PPPL ENGINEERING CHANGE NOTICE (ECN) ECN # 5140R1

ECN TITLE: Changes to Modular Coil Lead Area Design

AREA OR PROJECT: NCSX

The purpose of these lead area design changes is to mitigate technical risks that have come to light in the course of testing the C1 Modular Coil. The following changes are proposed:

Figure 1

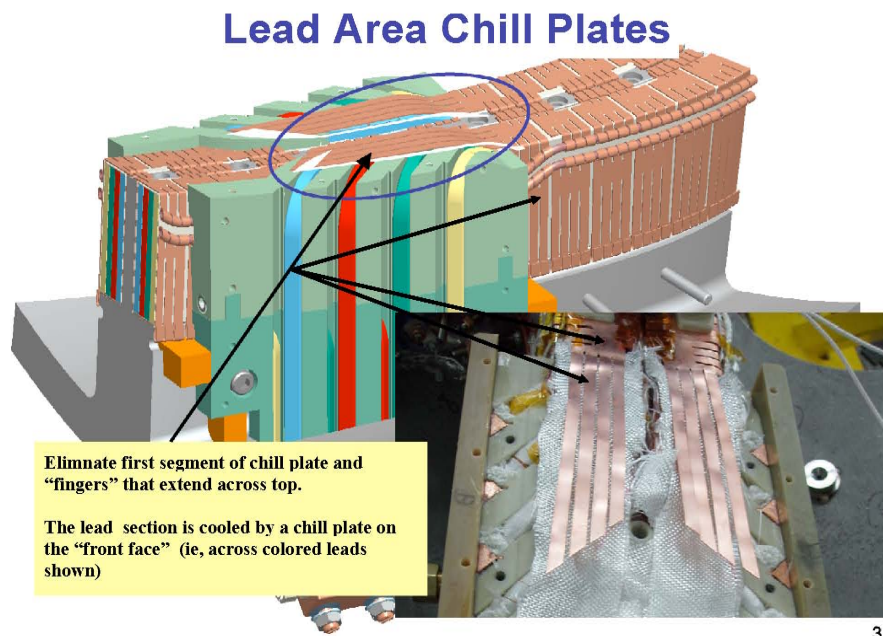
- On the top chill plate (the one with the long fingers that extend parallel to the coil) – cut off the fingers and eliminate the chill plate. **(See Figure 1)**. *This change will be implemented for the C3 and follow-on coils.*

Figure 2

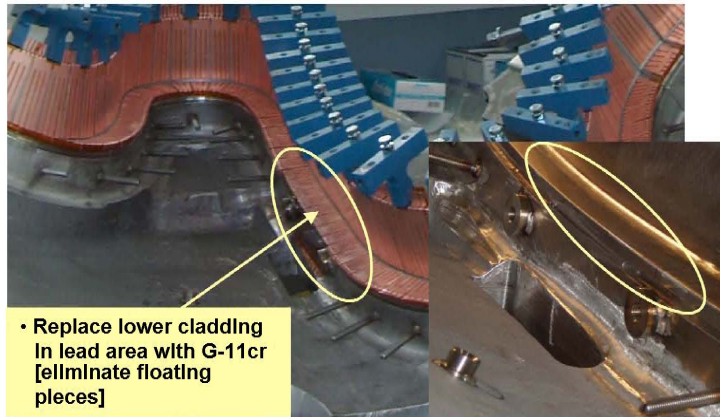
- Isolated copper cladding pieces (located on the base of the tee underneath the winding pack in the lead area, the vertical cladding pieces in the same area, and the cladding in the poloidal break area) – change the material to G-11cr. **(See Figure 2)**. *This change will be implemented starting with the C5 and follow-on coils.* Note: The G-11 pieces should be made to look like the cladding (with slots) so that forming to the shape and wicking of epoxy will be that same as for other areas.

Figure 3

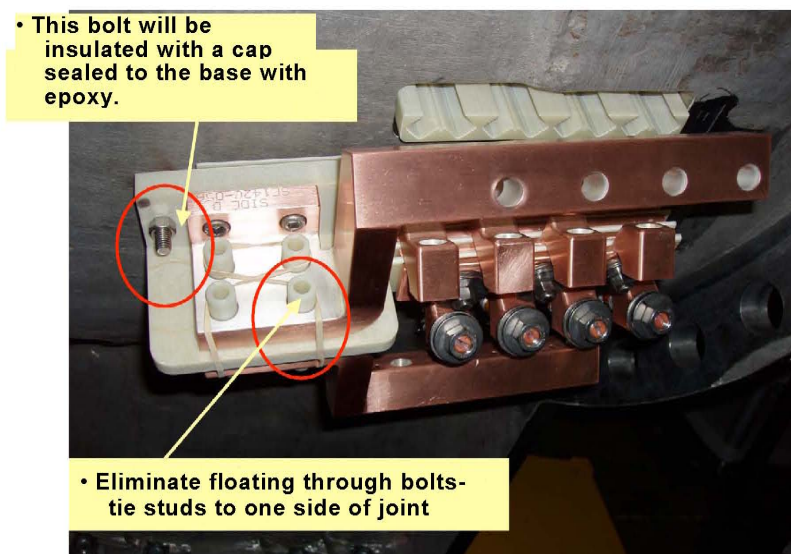
- For the power bus tie-in area, cap the attachment bolt with an epoxy seal to mitigate a potentially short tracking path.. **(See Figure 3L)**. *This will be implemented on all coils.*

- Presently the four bolts that connect the power bus are floating which is an undesirable condition **(See Figure 3R)** - connect them to one side by eliminating the insulating washers on the other side. *This will be implemented on all coils.*

Figure 4

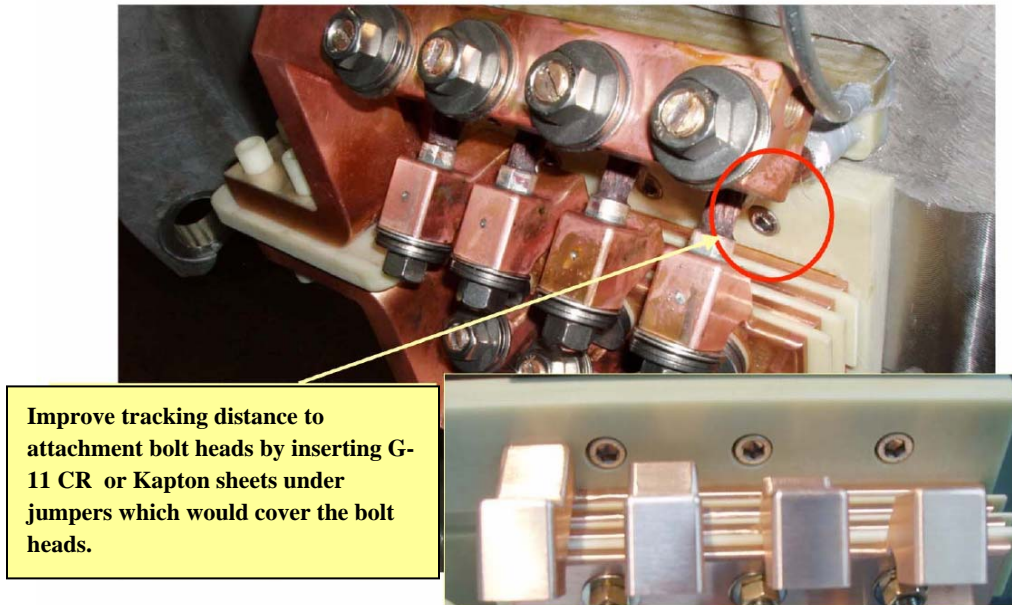
- The bolts that attach the G-11 base plate underneath the jumper stack – put a cover (Kapton or thin G-11 sheet) to increase the tracking distance. **(See Figure 4)**. *This will be implemented on all coils.*
